Atmos. Chem. Phys. Discuss., 13, C8482–C8488, 2013
www.atmos-chem-phys-discuss.net/13/C8482/2013/
© Author(s) 2013. This work is distributed under
the Creative Commons Attribute 3.0 License.

Interactive comment on "Reductions in aircraft particulate emissions due to the use of Fischer–Tropsch fuels" *by* A. J. Beyersdorf et al.

Fig. 1.

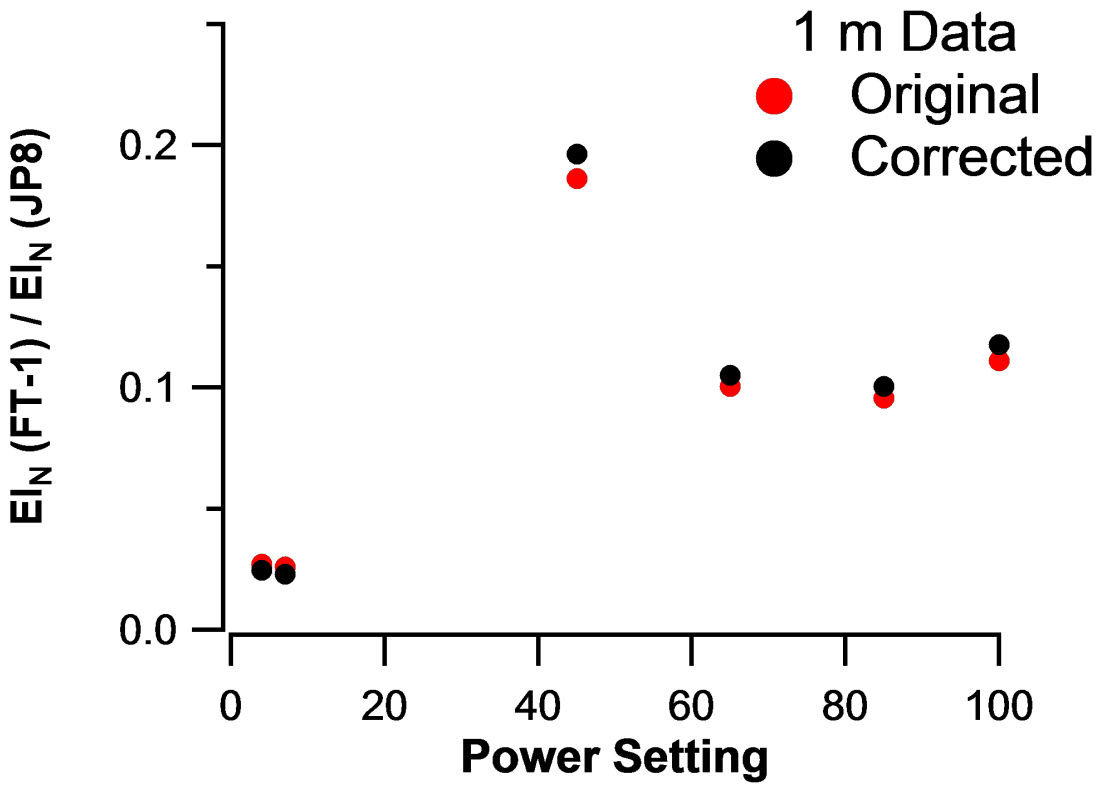
5) Line 21 (the VMD), shows there is a difference in size between fuels. How much of the reduction in EI_N is due to the fuel and how much is due to a potential size dependent loss down the sample line and indeed the relative difference between lines. All the sections need tightening up on what are quantifiable differences between fuels and how much are within experimental errors caused by, for example, line losses.

A small size dependence was seen in the transmission efficiency. However, this correction would only result in a very small shift in the size distribution. Figure #1 (attached but not included in the paper) shows the relative EI_N for FT1 (FT1/JP8 for EI_N). The corrections resulted in changes in reductions of less than 2.5% for all powers and all fuels. Also, Figure #2 (attached but not included in the paper) shows the change in size distribution resulting from the line loss correction. It is hard to see as the VMD
